# Service Information

## **MCU & CD BOARD CHANGES DURING PRODUCTION**

CIRCUIT DIAGRAM - MCU & CD BOARD  
Main Part

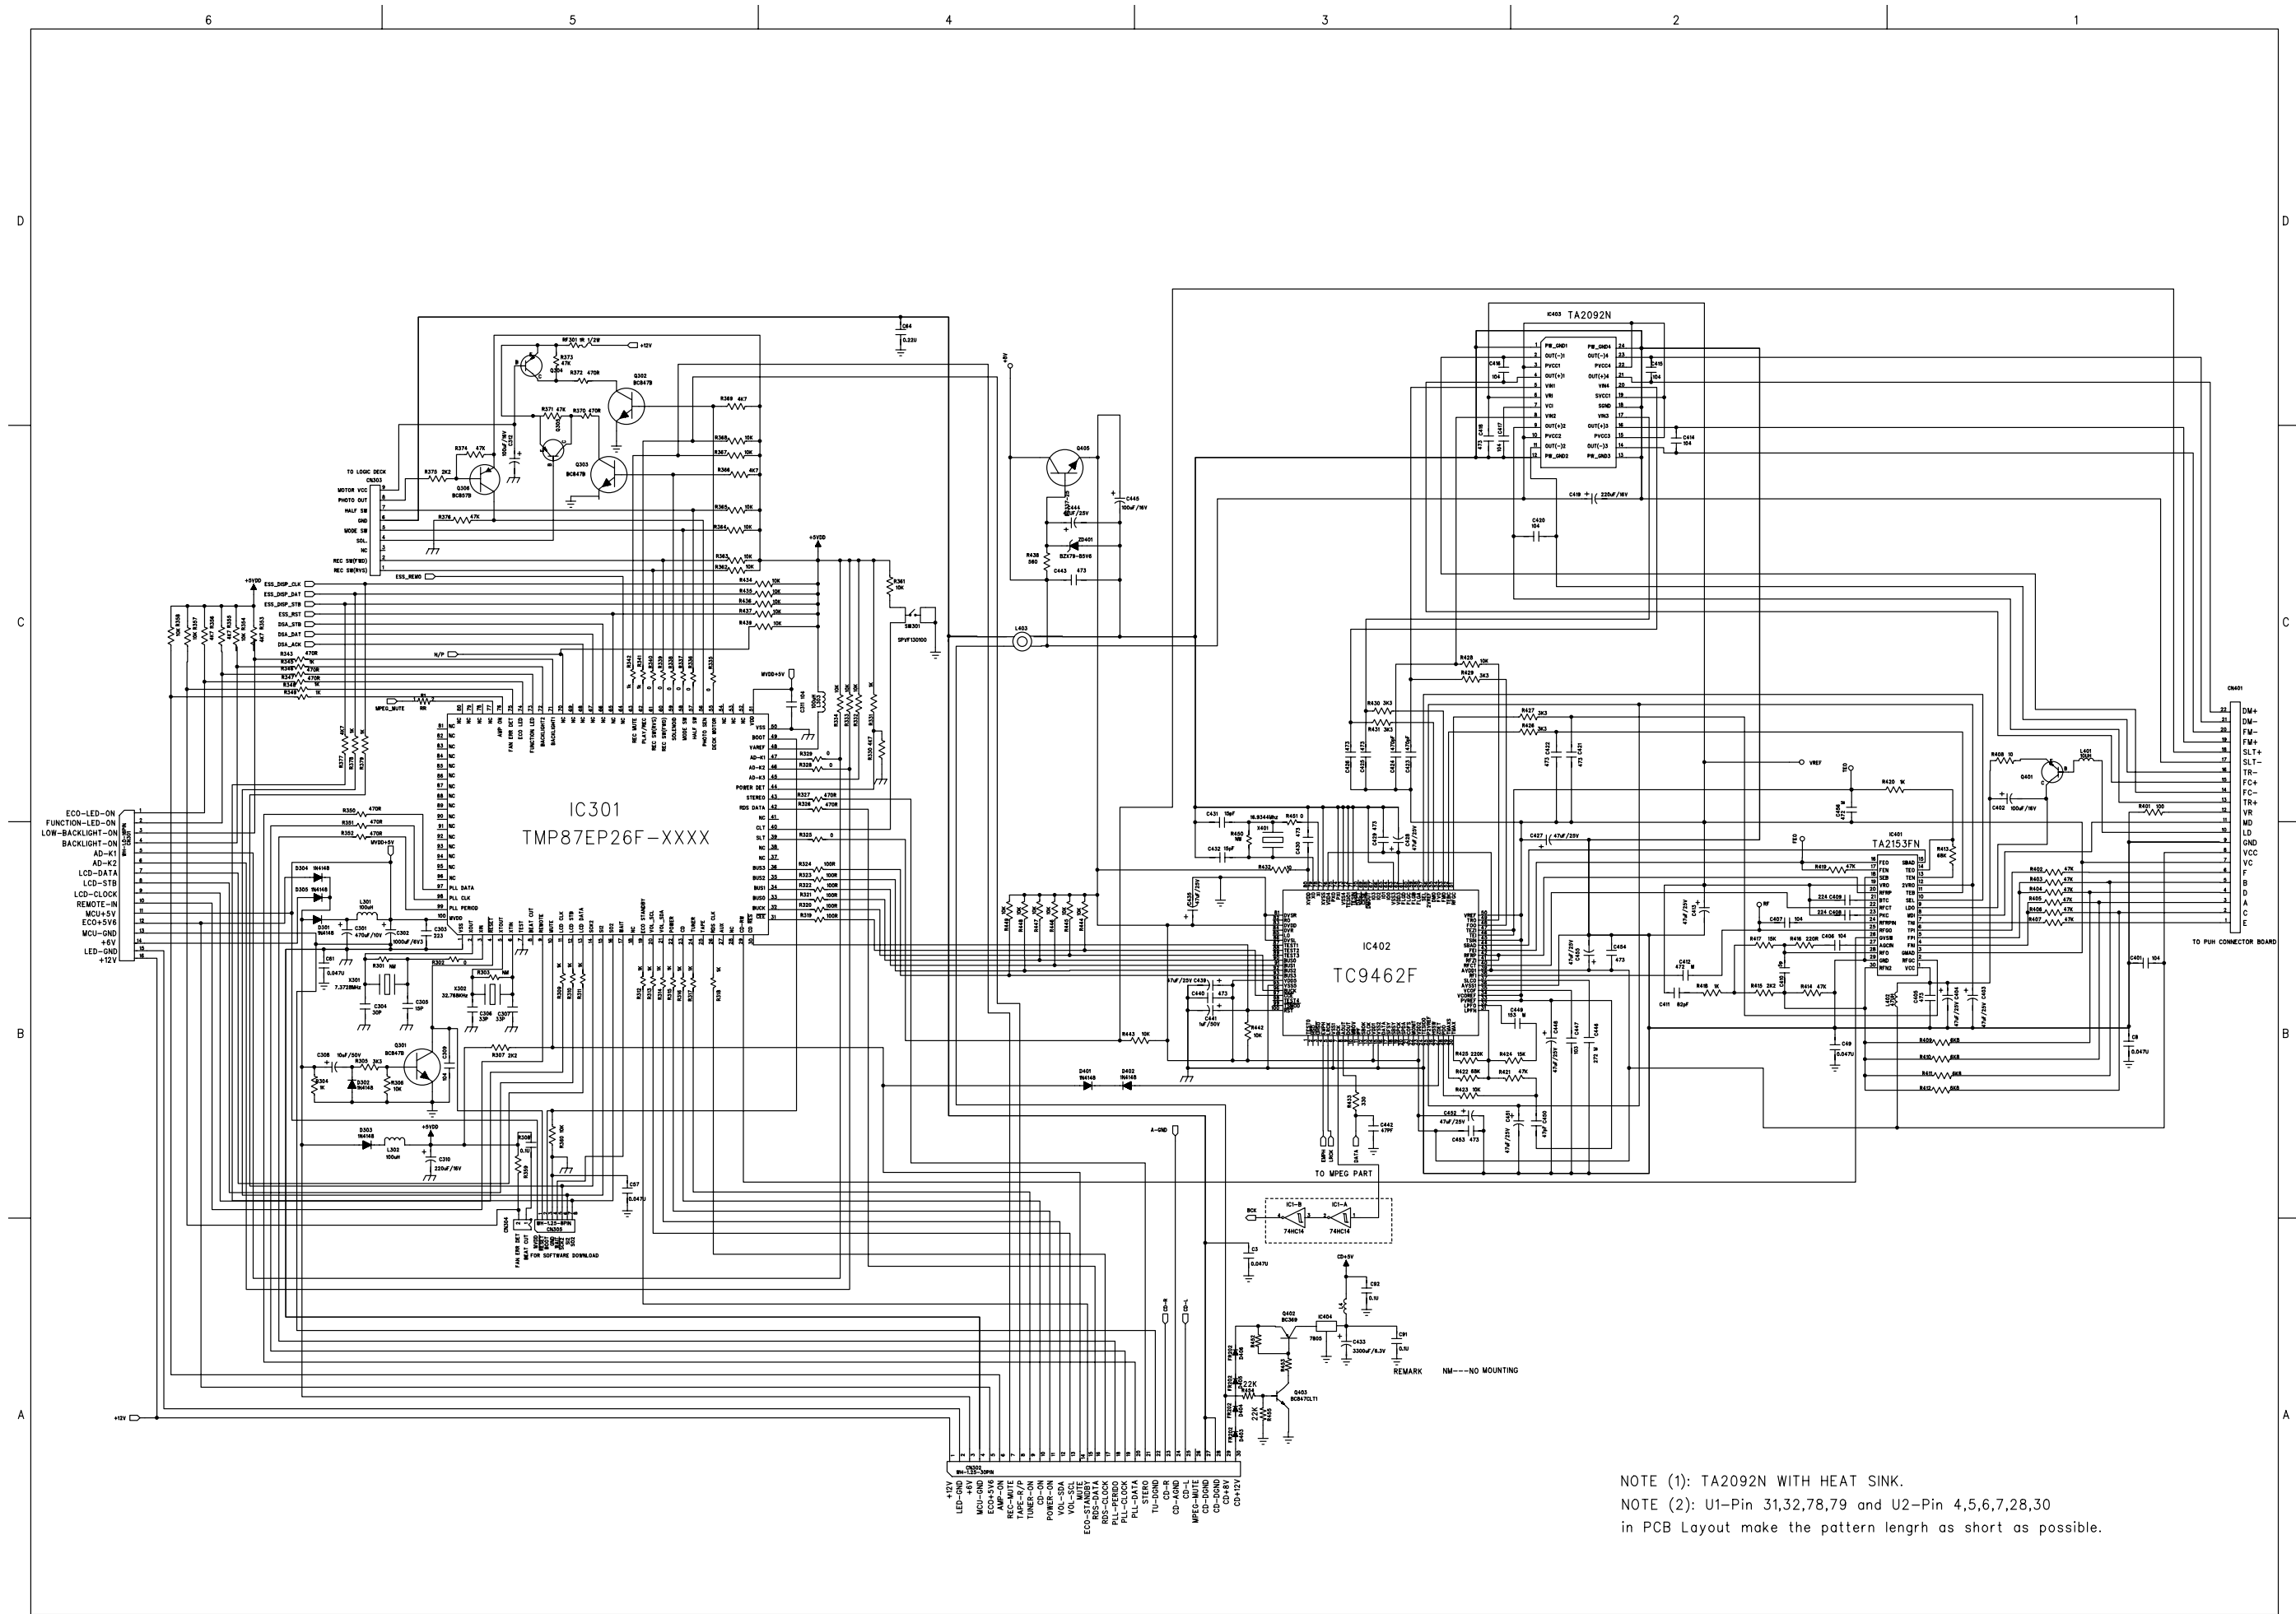
\*From production week 0330 onwards the MCU & CD board has been modified in order to eliminate the pink noise during CD playing.

Add IC1 5322 209 11548 MC74HC14AD

For servicing the new MCU & CD board, please refer to the attached pages.

CIRCUIT DIAGRAM - MCU & CD BOARD  
MEPG Part

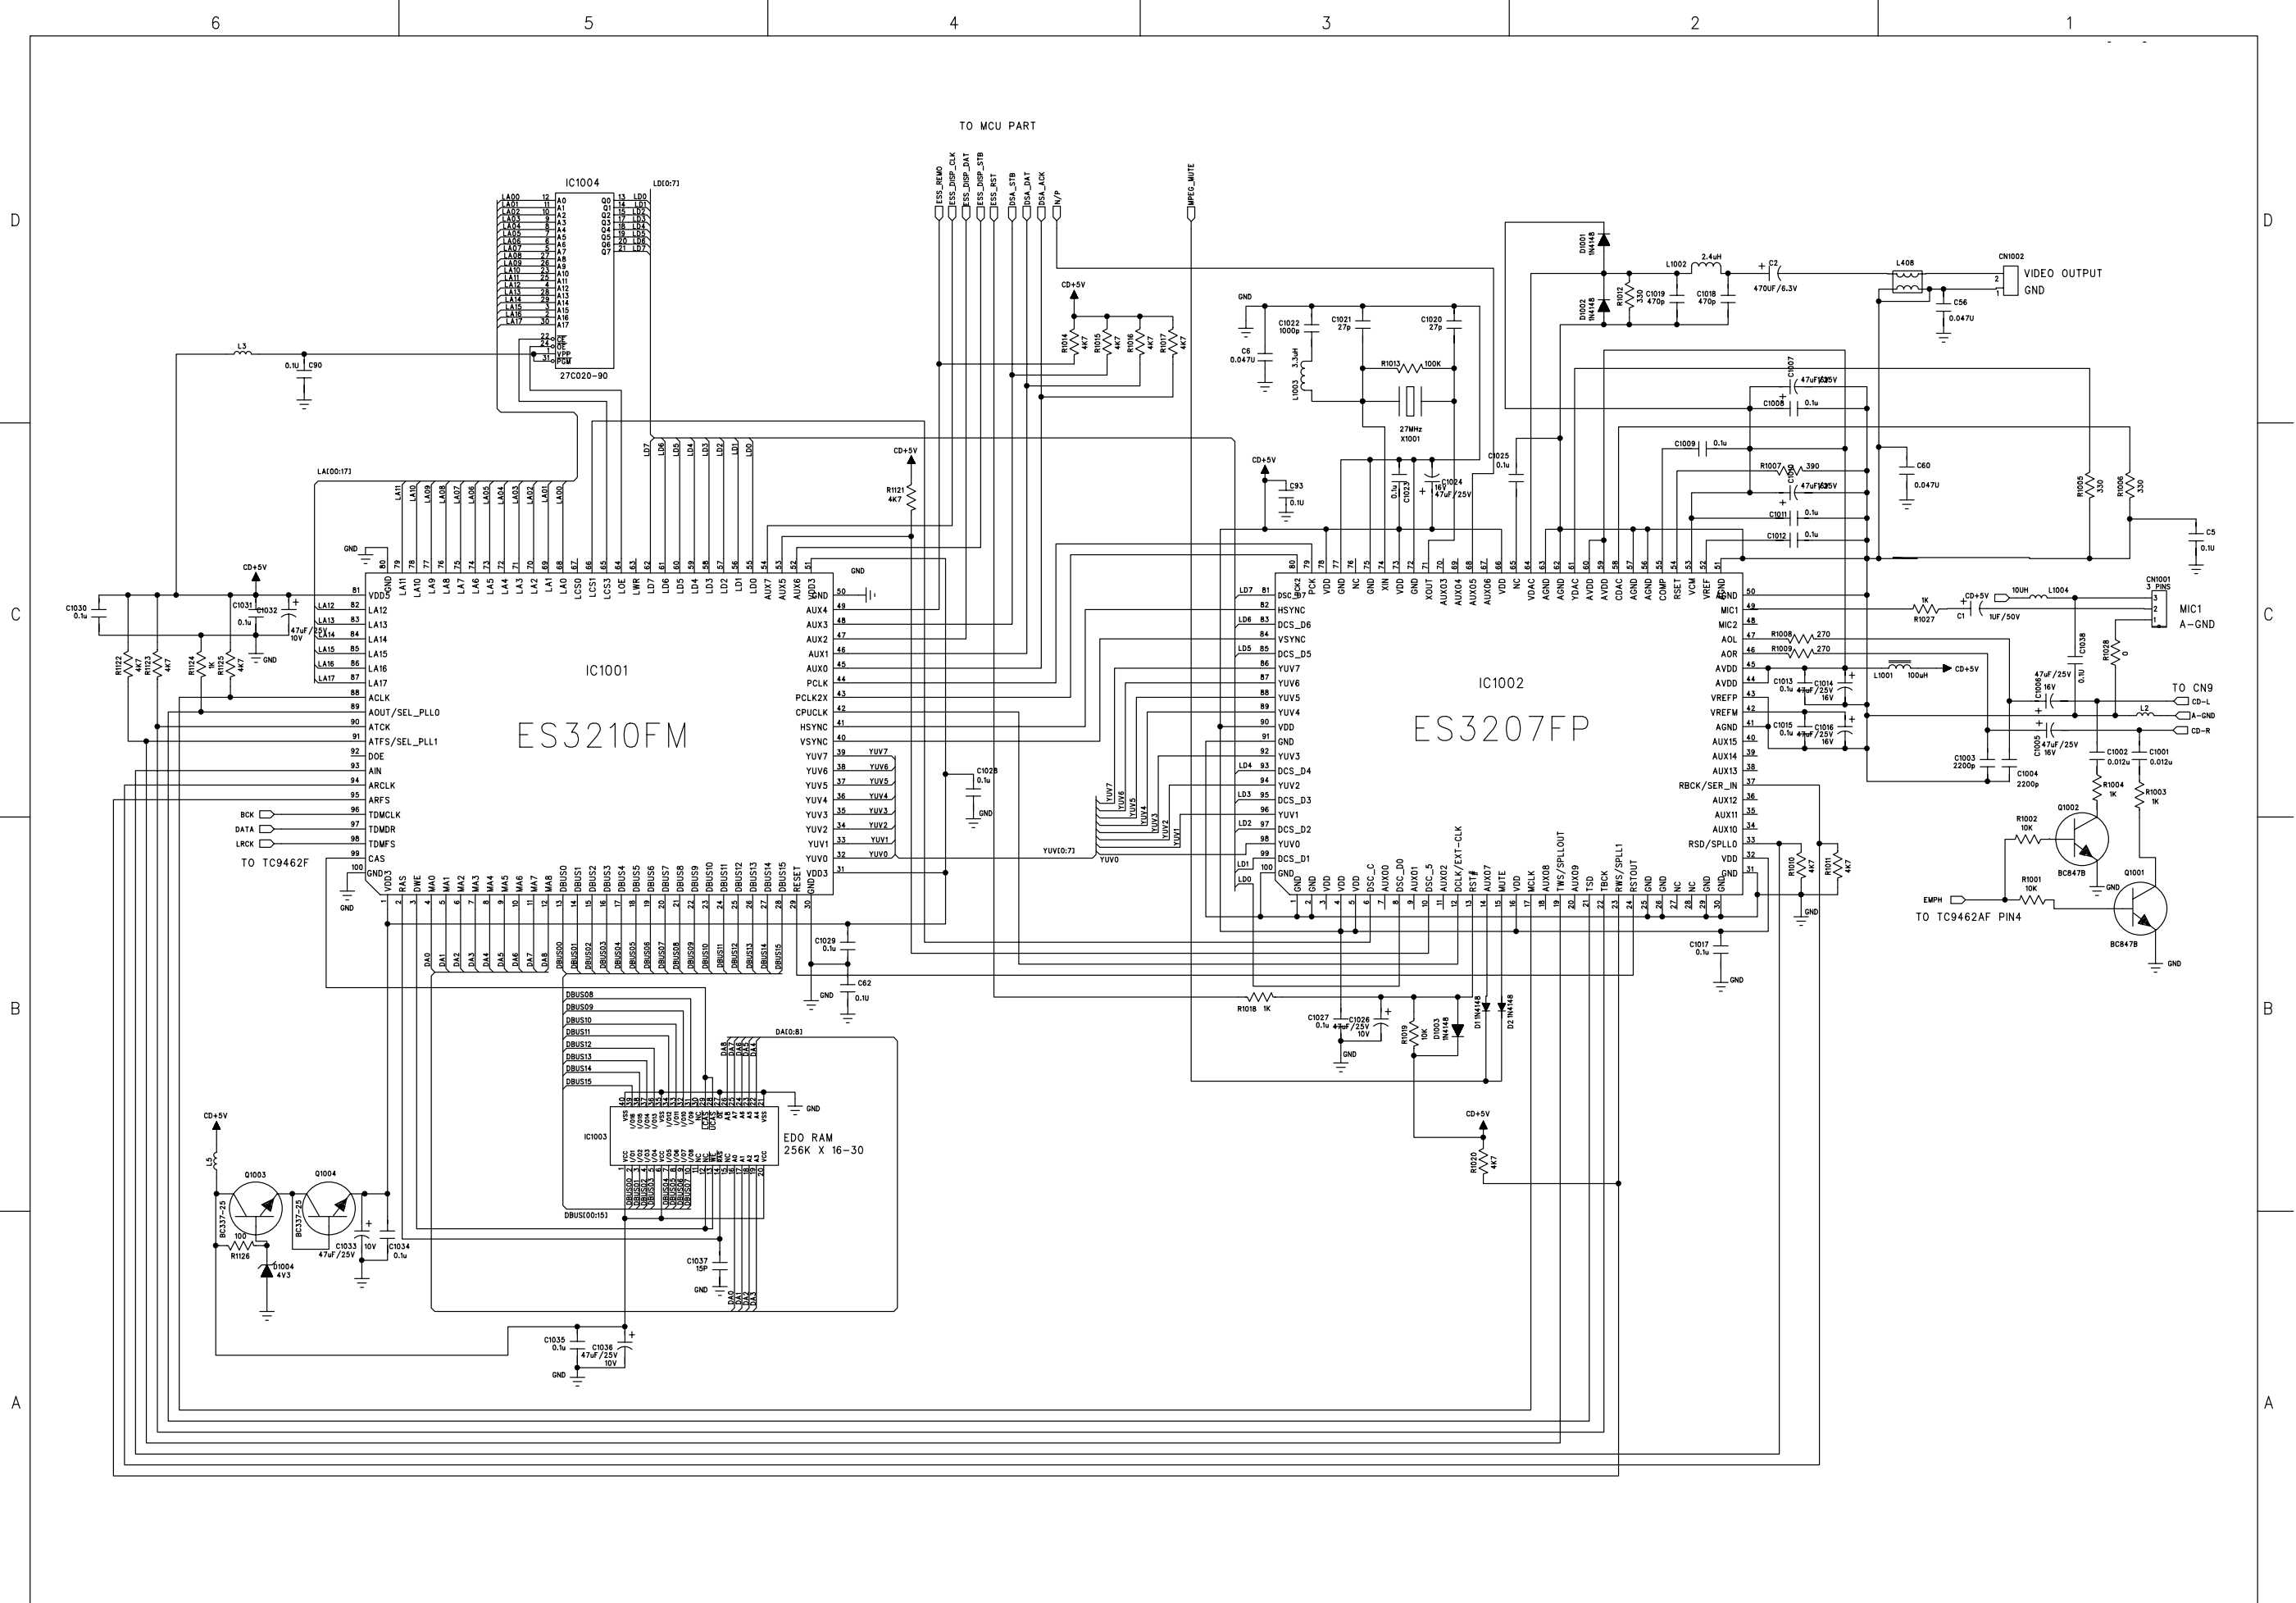
\*From production week 0330 onwards the following has been changed due to no need of video out.

Delete L1002 9965 000 19760 FIXED IND. 2.4UH /22/25
